H11896

Type of Survey Shallow Water Multibeam
Hydrographic and Side Scan Sonar Survey

Field No. OPR-H328-OS-08-A

DESCRIPTIVE REPORT TO ACCOMPANY HYDROGRAPHIC SURVEY H11896

Figure 1. Shoal encroaching on Outer Bar Cut Outer Right Quarter (37.2 foot contour in red)

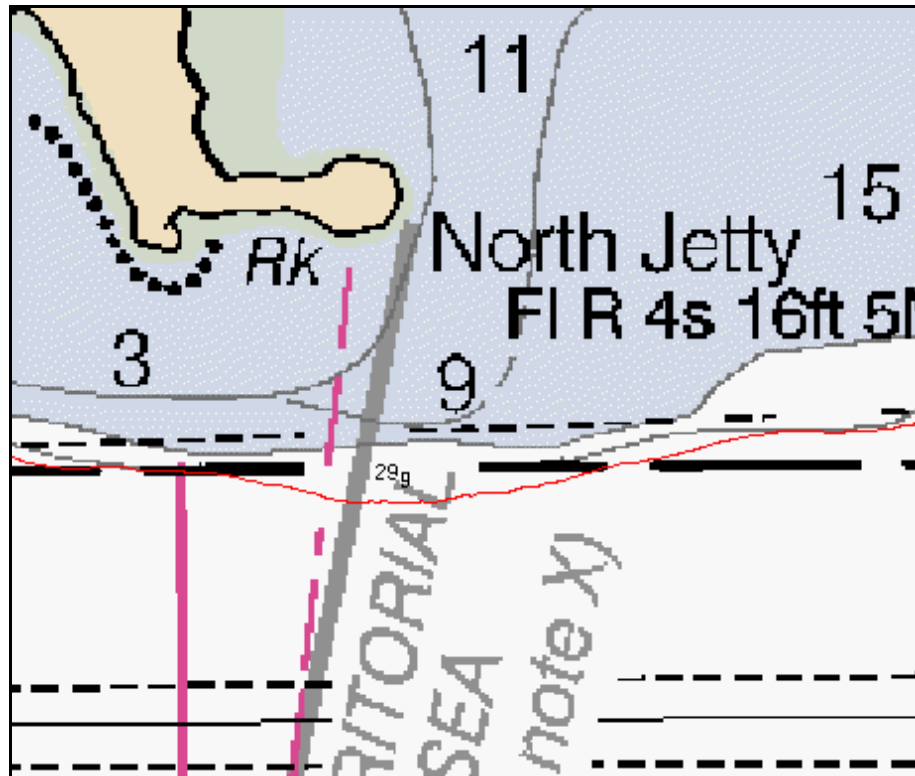
Feature 1 : A shoal on the northern side of the Outer Bar Cut Right Outside Quarter is encroaching on the channel in the vicinity of the east end of the north jetty. A shoal sounding of 29.9 feet (9.1 meters) was observed at 80-06-16.46, 26-05-39.43 at the northern limit of the Outer Bar Cut, south of the charted North Jetty. The 37.2 foot (11.3 meter) contour extends approximately 20 meters south into the channel on a steep slope.

Concur -- Add 30 ft depth.

Figure 2. Obstruction with 11.2 meters depth within the Bar Cut Outer Left Quarter.

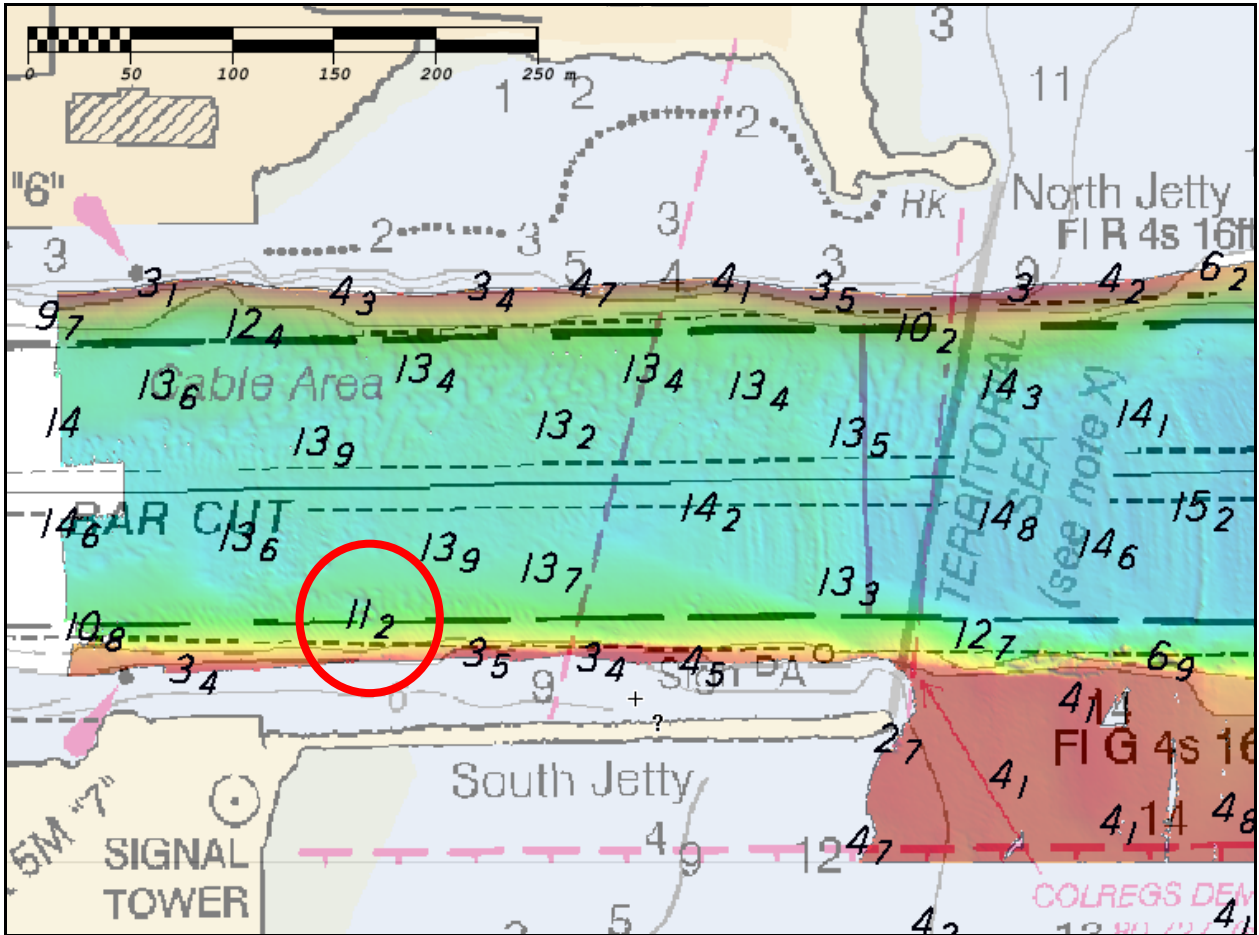
Feature 2: A rectangular obstruction with a least depth of 36.8 feet (11.2 meters) was observed within the Bar Cut Left Outer Quarter at 080-06-27.49, 26-05-34.89. The obstruction has the following approximate dimensions of 24x12x6 (LxWxH feet).

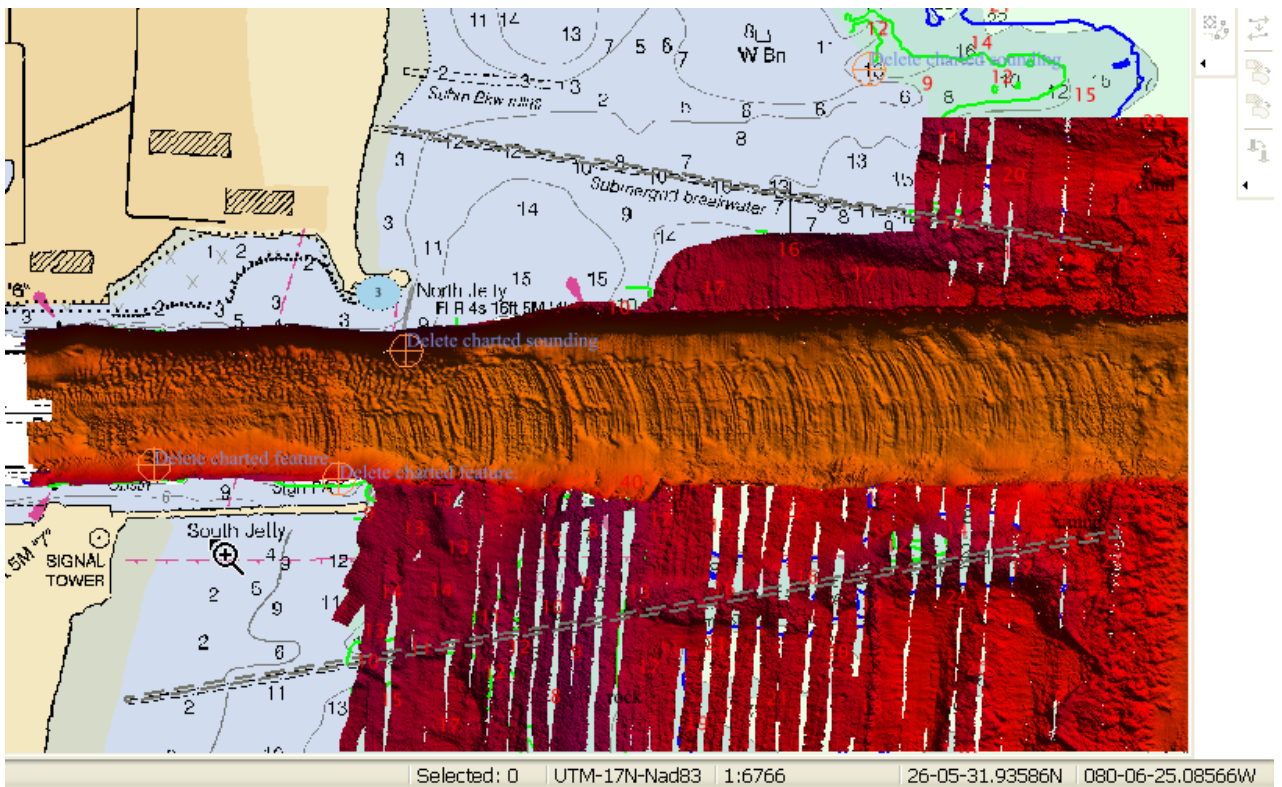
A charted Obstns PA, area in Latitude 26°08'25"N, Longitude 080°04'19"W was partially disproved by the present survey. Present survey depths are 124 to 162 feet. Depths are in harmony with the chart. The Obstns, PA limits have been revised. The revised limit was brought forward from ENC US5FL33M, 20100316. It is recommended that the Obstns PA, area be revised as shown on H-Cell.
